Flying Spur

E796

Transaction No.: 2034962/1

Radiator shell and securing strip clip specification (SC13/19)

Figure 3

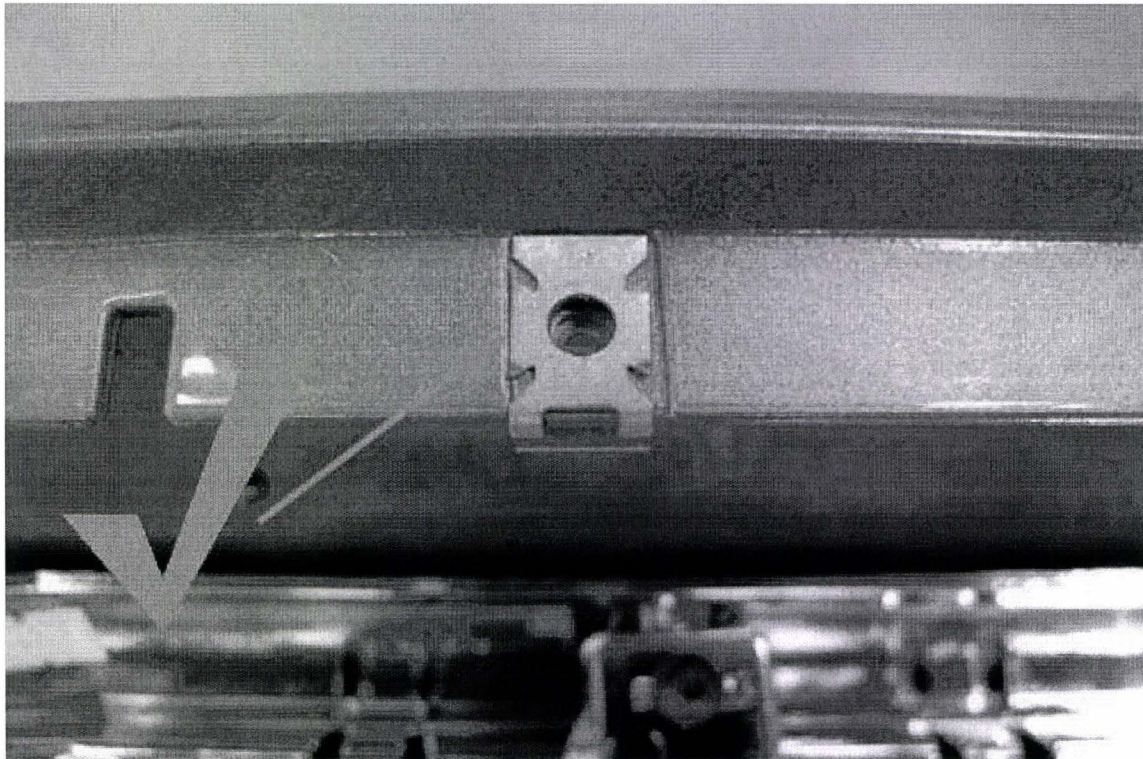
- Check the top radiator clip specification as follows:
- Should the spring clips be found to be silver (Figure 3) these are correct and should not be replaced, please go to procedure 2

Figure 4

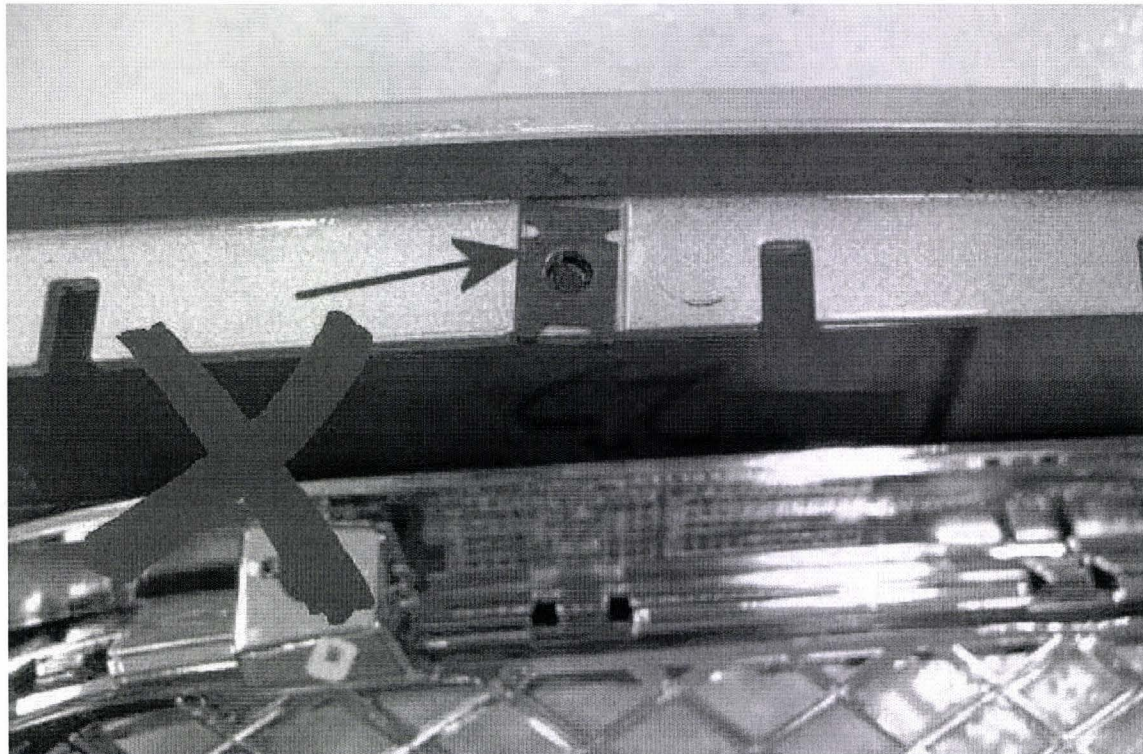
- Should the clips be found to be black (Figure 4) these are incorrect and must be replaced

Figure 6

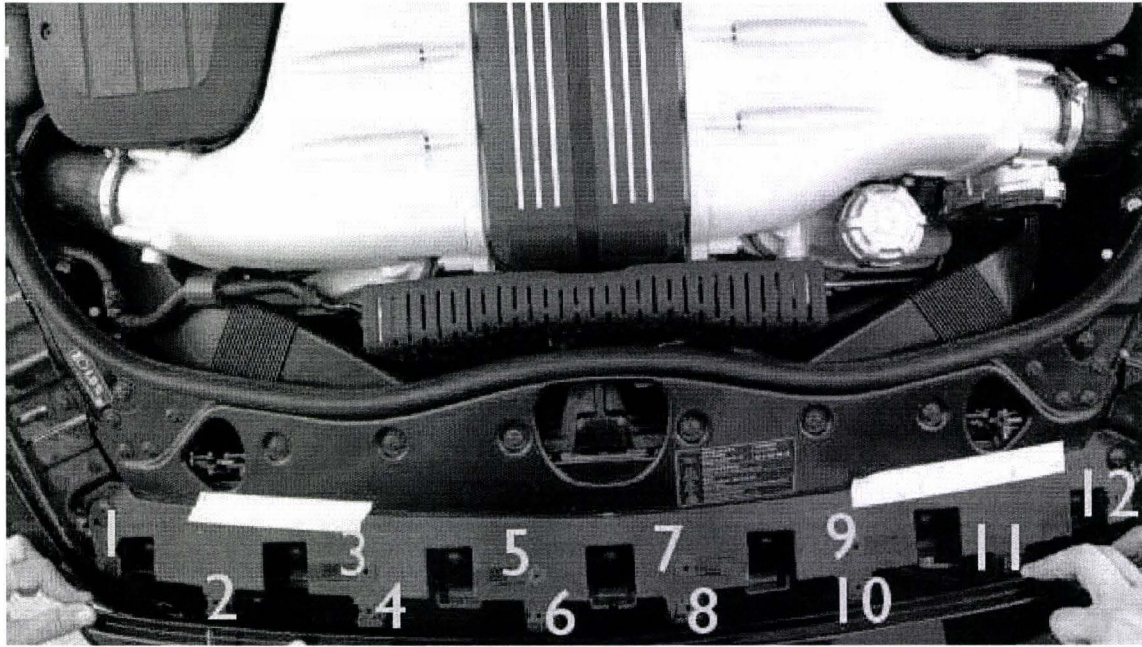
- Remove and discard the twelve original black clips as shown in Figure 6 and replace with new silver clips **NOTE:** In the event that silver clips are found to be already fitted there is no requirement to replace the existing silver clips
